Work Order ID 90605

Item Name: Rear Locker Extender

Issue P/O: *17976*
Description: D350-604-041 Rear locker extender.
Supplier: Delastek.
Certification of Conformity and process sheet from Delastek is required.

Work Order: <u>90605</u> Part No. <u>D350-604-041</u> NCR No. <u>12-2008</u>	DISPOSITION Rework <input checked="" type="checkbox"/> Scrap <input type="checkbox"/> Use-as-is <input type="checkbox"/> Work Order Update <input type="checkbox"/>	AGAINST DEPARTMENT/PROCESS

D2273 REAR LOCKER EXTENDER

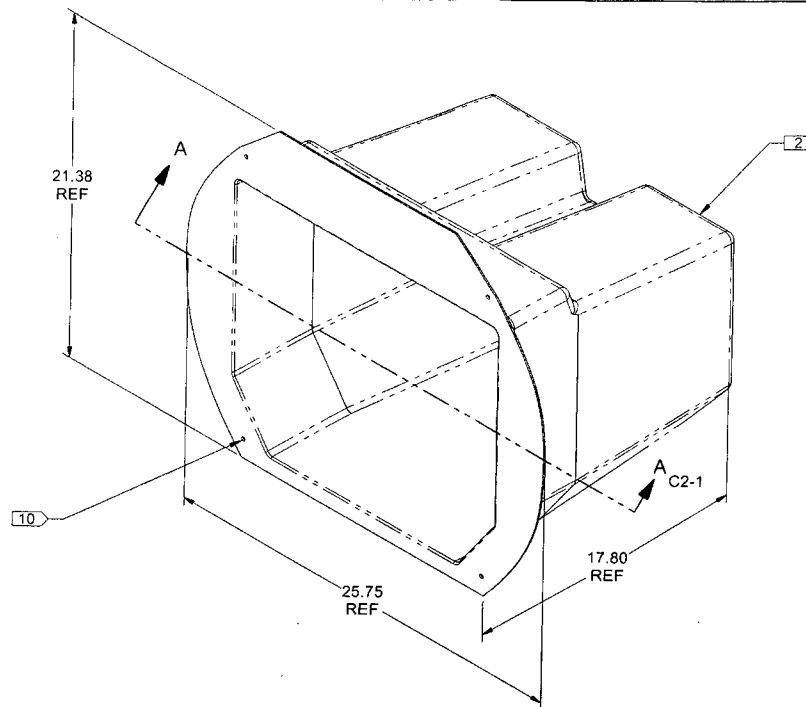
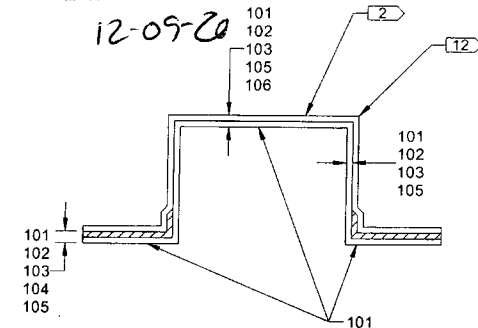
Root Cause		Date	Step	Qty	Description of work order update or Non-conformance	Initial Chief Eng	Action Description	Sign & Date	Verification	QC Inspector
Doc/Data		12/11/12	# 110	(1)	Found at inspection that the beam lockers are very rough & on the outside and the primer is not adhering (Flaking off) (see pic's)	 DAS 16 12/11/12	→ Remove All Primer + SANDS lightly to smooth out Fins	AS 12-11-14	 DAS 16 12-11-14	 DAS 16 12-11-12
Equip/Tooling							Re Prime As Per 205	AS 12-11-14		
Operator							inform supplier (slow)			
Material							4.10.05			
Setup							see Mike Emril			
Other										
Process										
Supplier	X									
Training										
Unapproved

Hope all is good. I came in this morning and started to inspect the latest rear lockers that was received in here at Dart on the 1st of November and found the outside finish is way too rough and the primer is flacking off. I have attached pictures of the problems.

To me the primer flacking off would be the results that the rear lockers were not scuffed enough for the primer to correctly adhere to the rear lockers. Also the outside finish is way too rough to pass. I think again your team will have to sand/buff the outside before applying the primer will solve the issue of the roughness as well.

I am surprised that the lockers were not acceptable as I was informed by my team that they were the best we had sent. I will share the pictures with them and assure that this will not happen with any future delivery.

I think that the rework can be done here at Dart so there is no need to return the rear lockers but I hope that this little issue can be rectified at your end and if there are any questions please call and we can figure out the solution.
